**Subject: Body Fit Training; Redondo Beach, California
Acoustical Design Review
Veneklasen Project No. 7233-168**

Veneklasen Associates, Inc. (Veneklasen) has reviewed the drawings for comparison to the local municipal code and tenant lease requirements. This report documents our acoustical comments. Veneklasen has summarized the comments into areas where modifications may be required.

M. Studio Wall Intersections

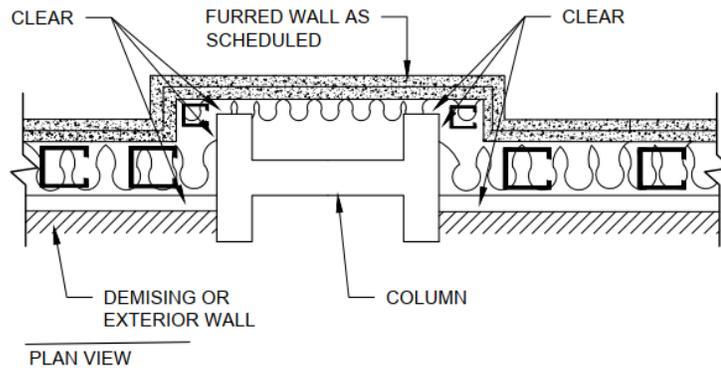
1. Where studio walls intersect with other walls, avoid rigid connections between the framing and gypsum board of the two assemblies. Provide a 1/4-inch gap at the perimeter of all acoustical wall assemblies and fill gap with acoustical or fire-rated sealant. This is noted on sheet A1.0 (note 15). Inclusion of a construction detail may be beneficial. Refer to conceptual details below.

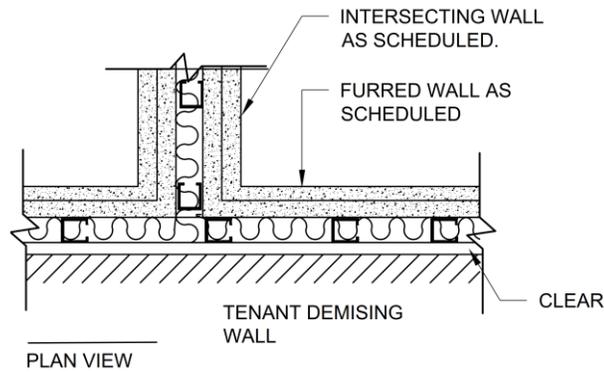
2. Studio walls at columns. Avoid contact between columns and studio furred walls. Refer to conceptual detail below.

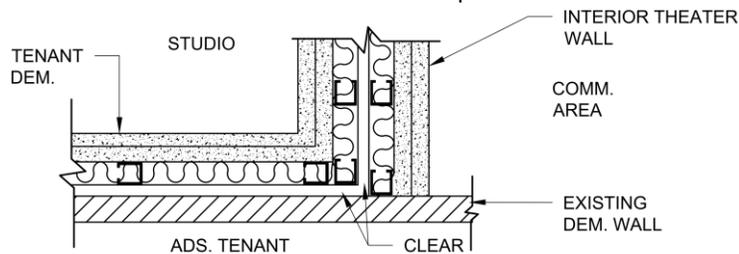
3. Studio and interior wall intersection. Refer to conceptual detail below.
